Final Product/Process Change Notification

Document #:FPCN24563XC

| Title of Change: | UTAC Thai Limited Assembly site expansion for non-automotive. | |

Illustration of case outline showing the exposed pad dimensions D2 and E2

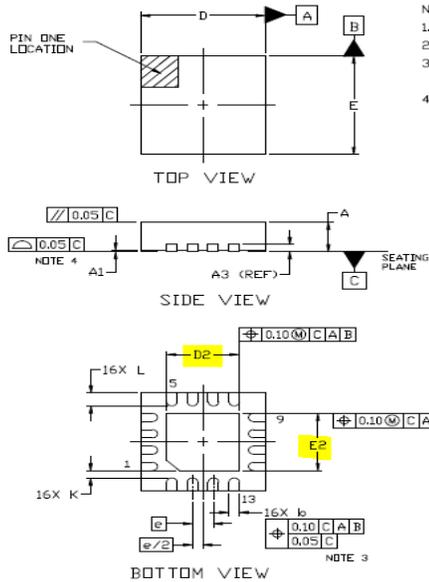
Add UTAC Thailand Bangsamak site as alternative assembly site by apply same machine model and same material. Including update in case outline dimensions D2 and E2 tolerances for the exposed pad have increased by 0.10 mm. This does not affect the Recommended Mounting Footprint shown on the case outline drawing

| | Before Change Description | | After Change Description | |
|--|--|---------------------------|---|--------------------------|
| Case Outline Dimensions D2 & E2 | See illustration below for D2 and E2 dimensions. | | See illustration below for D2 and E2 dimensions. | |

| | Before Change Description | | After Change Description | |
|--|--|---------------------------|---|--------------------------|
| | D2 | 1.70, 1.75, 1.80 | D2 | 1.65, 1.75, 1.85 |
| | E2 | 1.70, 1.75, 1.80 | E2 | 1.65, 1.75, 1.85 |
